AERONAUTICAL CHARTING MEETING Charting Group Meeting – October 28 - 29, 2020

RECOMMENDATION DOCUMENT

FAA Control #20-02-345

Subject: Wrong Surface Hot Spots and Surface Hot Spot Standardization

LINCOLN (LNK) LINCOLN, NEBRASKA

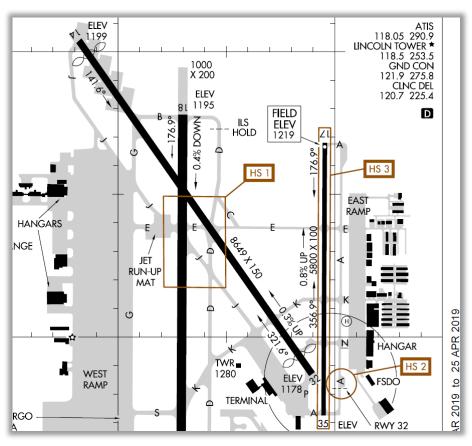
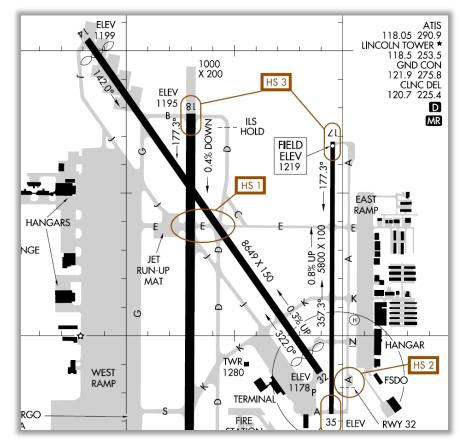
- Standardize both surface based and wrong surface hotspots.
- Implement three shapes as part of the standardization.
 - Cylinders to represent Wrong Surface Hot Spots
 - Circles or Ovals to represent Surface Based Hot Spots, depending on the size and shape of the area of the confusion.
- Implement the inverted MR on the Airport Diagram in the top left corner to indicate there is a misalignment risk potential.
- Implement the MR on the Approach Plate in the sketch view.
- Define the MR in the Charting Specifications to address a potential for a misalignment risk and points to more information.

CURRENT

PROPOSED

LINCOLN (LNK) ARRIVAL ALERT

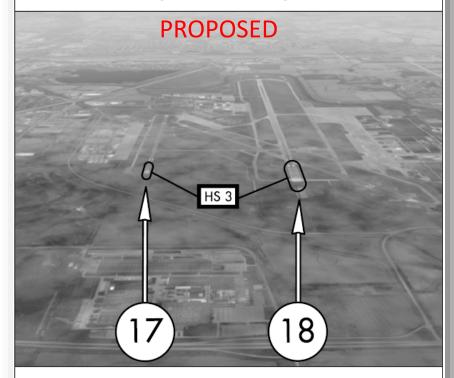
- Implement a new Arrival Alert page which aids the pilot in a visual reference of a particular approach.
- Outreach and Education will take place prior to implementation to include the following:
 - o Single Topic Video
 - o Briefings to Industry stakeholders and Stakeholder Webinars.
 - Presentation to the National Association of Flight Instructors (NAFI)
 - Flight Standards FAAST blasts
 - Webinars
- Proposed implementation in December 2020.

Landing South Misalignment Risk Rwy 17 and Rwy 18

Pilots arriving on Rwy 17 need to be aware that Rwy 17 is 550 feet farther down the approach than Rwy 18.
